Title: Top-Sheet.SchDoc	
File: Powermodule-v7.0.3.PrjPcb	
Date: 21/10/2024	Page Num: 1
Drawn By: Huzaifa Ali	Page Total: 8

Title: Power_Section.SchDoc	
File: Powermodule-v7.0.3.PrjPcb	
Date: 21/10/2024	Page Num: 2
Drawn By: Huzaifa Ali	Page Total: 8

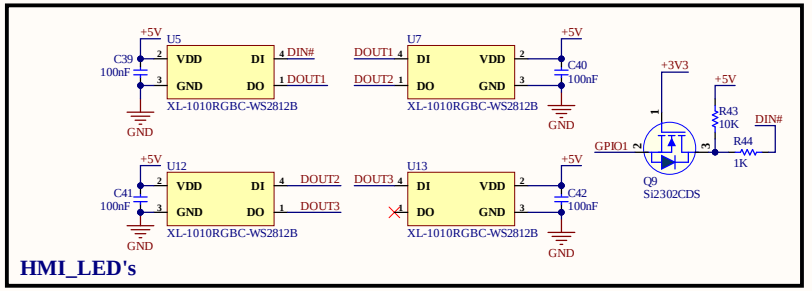
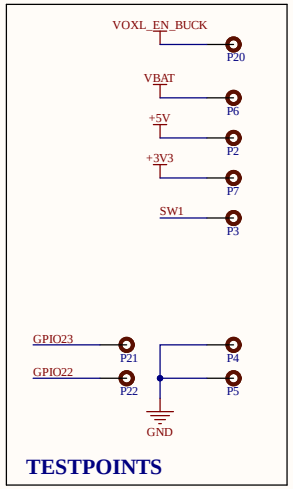
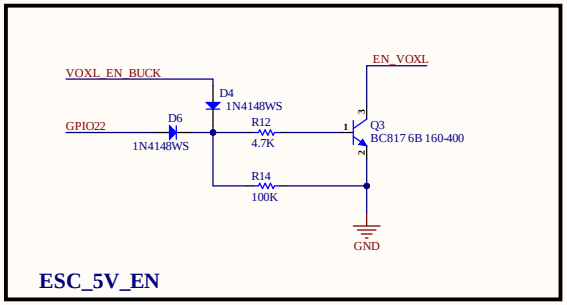
GPIO17 CHANGED FROM GPIO28
MISPRINT ON EAGLE SCHEMATIC

Title: Controller_Section.SchDoc		
File: Powermodule-v7.0.3.PrjPcb		
Date: 21/10/2024	Page	Num: 3
Drawn By: Huzaifa Ali	Page	Total: 8

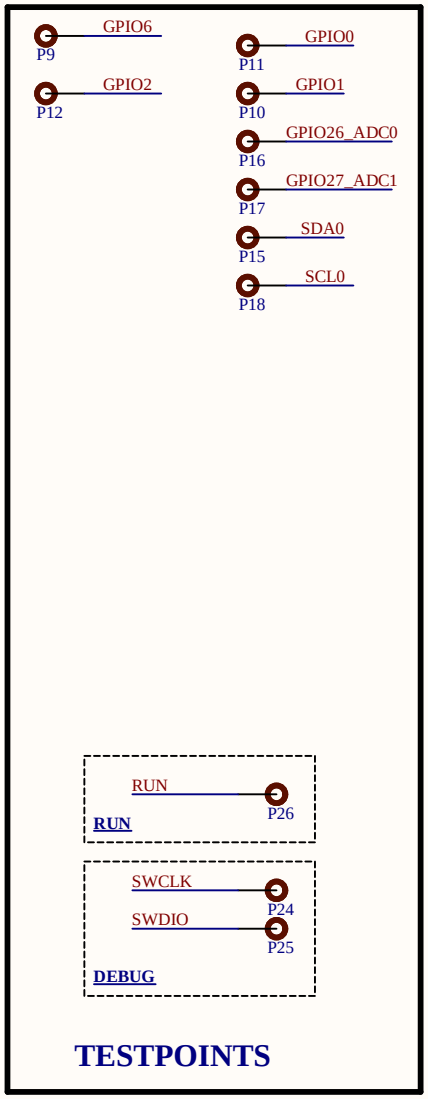
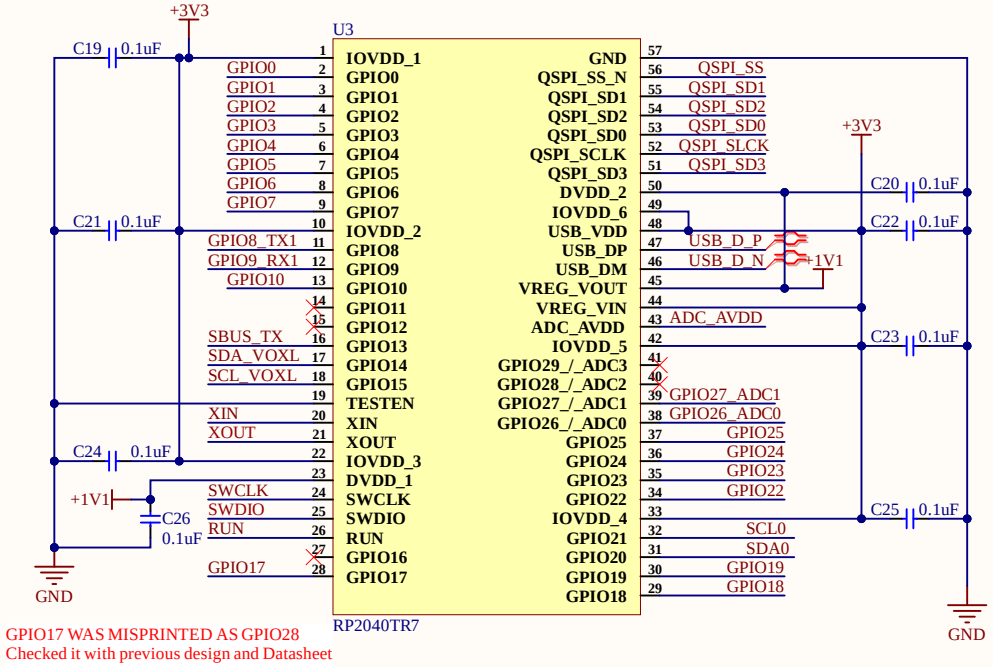
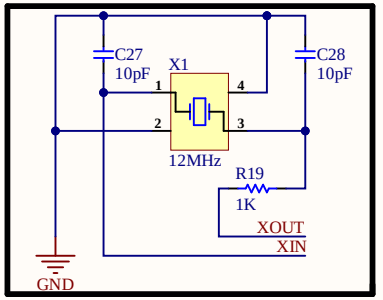
GPIO17 WAS MISPRINTED AS GPIO28
Checked it with previous design and Datasheet

Title: RTC_Section.SchDoc	
File: Powermodule-v7.0.3.PrjPcb	
Date: 21/10/2024	Page Num: 8
Drawn By: Huzaifa Ali	Page Total: 8

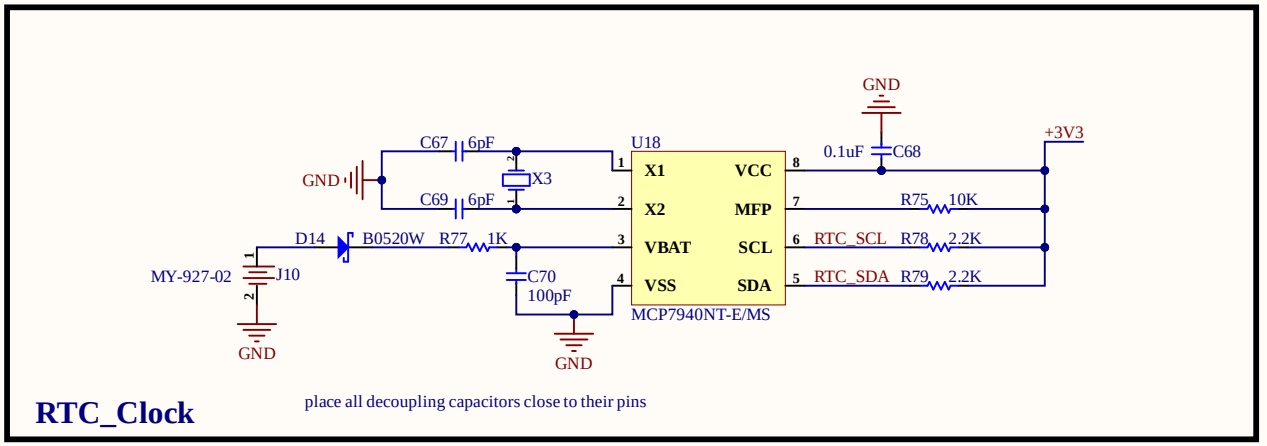
Add CR927 cell in peripherals
